# Office Action Summary

10/768,500

KASAHARA ET AL.

【图1】

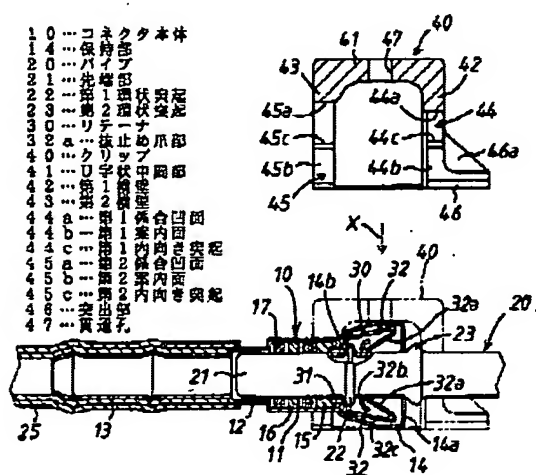
Claims 1-9 are rejected under 35 U.S.C. § 102(b) as being anticipated by Japanese patent 11-6591. The Japanese patent illustrates the present invention with tube 1 having an annular engagement projection 22 and an annular verification projection 23. The tube fits into the female connector 10 and is sealed therewith via seals 15,16 and retained therein via retaining means 32. Further a clip body 40 is presented having opposite U-shaped clip portions 42 and 43 for verifying correct connection of the tube within the female coupling. As shown in
